# Access Compliance Report

## Public Rights-of-Way

### (Curb Ramps)

Intersection ID: 9723	Main Street: J JULIAN LN	Cross Street: TUCKASEEGEE_RD	Location:	E
ADA ID: 10FB01AFF3EE	Ramp Type: Perp	Initial Pass/Fail: Fail	Overall Compliance: No	Severity Score: 10

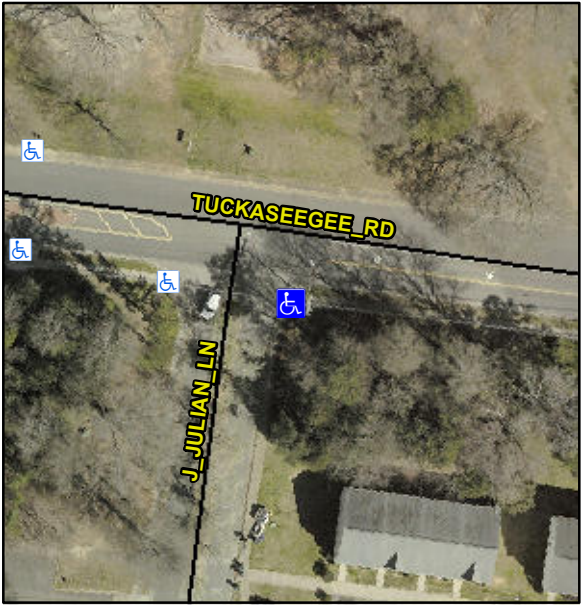
Codes/Mitigation Info/Possible Solution			Field Measurements/Component Compliance			
	Possible Solutions:		<b>Compliance</b>	<b>Description</b>	<b>Data</b>	
	<b>Remove &amp; Replace Entire Ramp.</b>		<b>N/A</b>	Ramp Length (in)	<b>73.0</b>	<b>Yes</b>
			<b>No</b>	Ramp Width (in)	<b>47.5</b>	<b>No</b>
			<b>N/A</b>	Flare Type LT	<b>N/A</b>	<b>N/A</b>
			<b>N/A</b>	Flare Slope LT (%)	<b>N/A</b>	<b>N/A</b>
			<b>N/A</b>	Flare Traversable LT?	<b>N/A</b>	<b>N/A</b>
			<b>N/A</b>	Landing Length (in)	<b>N/A</b>	<b>N/A</b>
			<b>N/A</b>	Landing Width (in)	<b>N/A</b>	<b>N/A</b>
			<b>N/A</b>	Landing Slope (%)	<b>N/A</b>	<b>N/A</b>
			<b>N/A</b>	Landing X Slope (%)	<b>N/A</b>	<b>N/A</b>
			<b>N/A</b>	Landing Curb? (Y/N)	<b>N/A</b>	<b>N/A</b>
			<b>N/A</b>	Shared Landing?	<b>N/A</b>	
			<b>N/A</b>	Gutter Ponding?	<b>N/A</b>	<b>N/A</b>
			<b>N/A</b>	Gutter Lip Ht (in)	<b>N/A</b>	<b>N/A</b>
			<b>N/A</b>	Painted X Walk1?	<b>No</b>	<b>N/A</b>

X Walk 1 Direction	<b>To W</b>	<b>N/A</b>
			<b>N/A</b>	X Walk 1 Width (in)	<b>N/A</b>	<b>N/A</b>
				X Walk 1 Slope (%)	<b>4.2</b>	<b>N/A</b>
				X Walk 1 X Slope (%)	<b>6.2</b>	<b>N/A</b>
			<b>N/A</b>	Ramp inside XWalk1?	<b>N/A</b>	<b>N/A</b>
<p>Surveyor Notes:</p> <p><b>N/A</b></p> <p>PROW/ADA:</p> <p><b>Not Found, R304.5.1, R304.5.3</b></p>			<b>N/A</b>	Road Slope (%)	<b>N/A</b>	<b>N/A</b>
			<b>N/A</b>	Road X Slope (%)	<b>N/A</b>	<b>N/A</b>
			<b>N/A</b>	Any Obstructions?	<b>N/A</b>	<b>N/A</b>
				Obstruction Type		
					<b>N/A</b>	<b>N/A</b>
			<b>Yes</b>	Surface Condition? (G/P)		<b>Good</b>
Total Cost:		\$ 1850.00
